TO:	Planning Board
FROM:	Jason Garnham, City Planner
DATE:	Meeting of April 5, 2022
RE:	507 Main St Site Plan Review
	Tax Map 37, Lot 6

Memorandum

> Saco Planning Board DRAFT Findings of Fact 507 Main St Map 37 Lot 6 Site Plan Review April 5, 2022

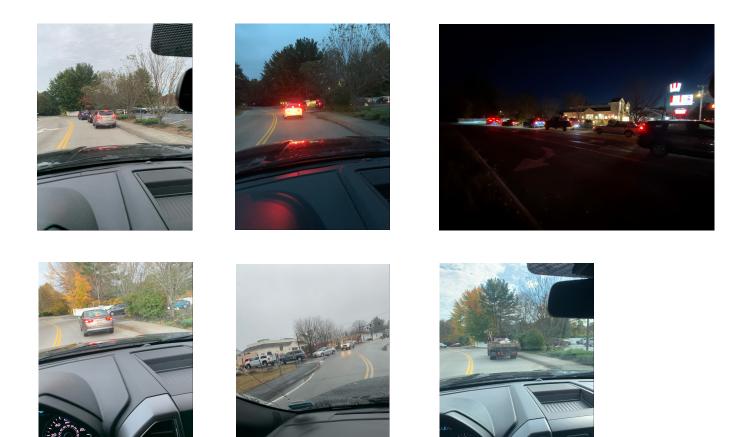
I wanted to pass these along again. I've also added another from just last week. All of these pictures have been taken during non-peak times of the year. Summer is much worse. Having reviewed the developer's plan and the traffic study, neither lengthening the right turn lane onto Route 1 nor changing the timing of the light will have any impact on this traffic issue. Please acknowledge receipt and ensure the planning board members receive copies before the April 5, 2022 meeting. Thank you.
